Office Action Summary	Application No.	Applicant(s)	
	10/750,684	JUNG, JAE HWAN	
	Examiner Donald Underwood	Art Unit 3652

DETAILED ACTION

FIG. 3

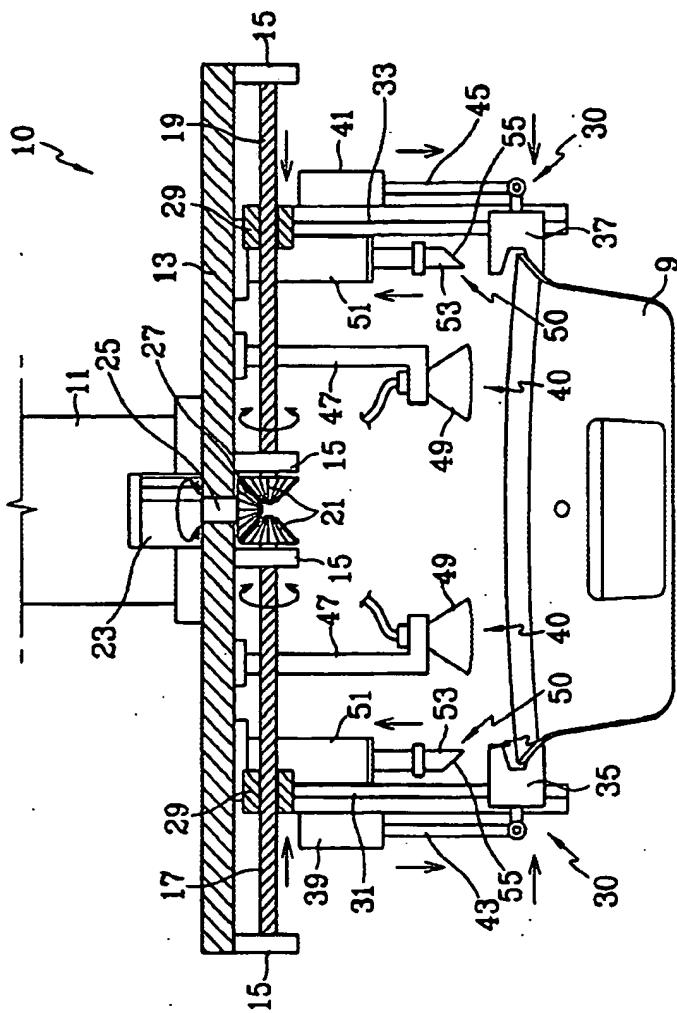
The drawing objection set forth in the Office action mailed 12/17/04 is herein repeated. The proposed replacement sheet filed 08/23/05 has not been approved since it does not contain figure 2. Note original sheet 2 of the drawings contained figures 2 and 3. The replacement sheet should also contain figures 2 and 3 or each of figures 2 and 3 should be submitted on separate replacement sheets. Further the replacement sheet filed 08/23/05 contains an extraneous bracket adjacent the Fig. 3 label which improperly appears beside instead of below the figure, i. e., the figure has been rotated 90 degrees. See the original figure 3.

not appeared
Wednesday 11/03/05
